Preliminary Acceptance Punchlist

El Paso County – Department of Public Works - Stormwater Section

Project Name:	Monument Academy CDR (road & roundabout)
EDARP Filing Number(s):	CDR201, CON2025 Also Reference: PPR199, CDR191, & MS2110
ESQCP Number:	ESQ1930 (Shared with school construction)
Attendees:	DPW SW: Shannon Mustoe, Joshua Augustenborg, Benjamin Jones DPW Development Services: N/A Developer: Matt Dunston
Date of Walk-through:	09-16-2024
Walk-through Number:	3 rd (First was 07/21/22, second was 01/25/2024)

Walker Rd (Sheet C2.1 of As Builts)

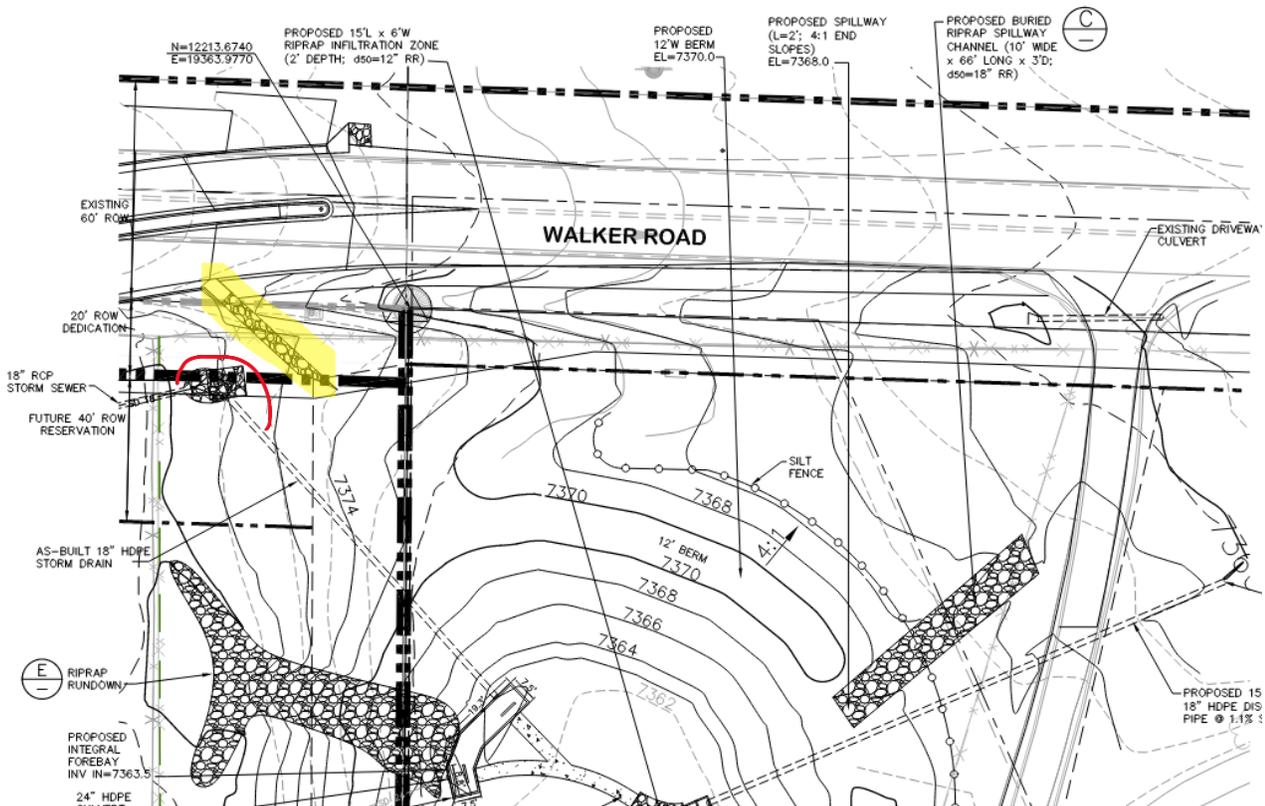
- Extend riprap rundown from curbside inlet off Walker Rd. and extend to pond. Currently, the flow from the street is not making its way into the pond. See markup below.
- Install berm around 18" HDPE storm drain. See markup below.
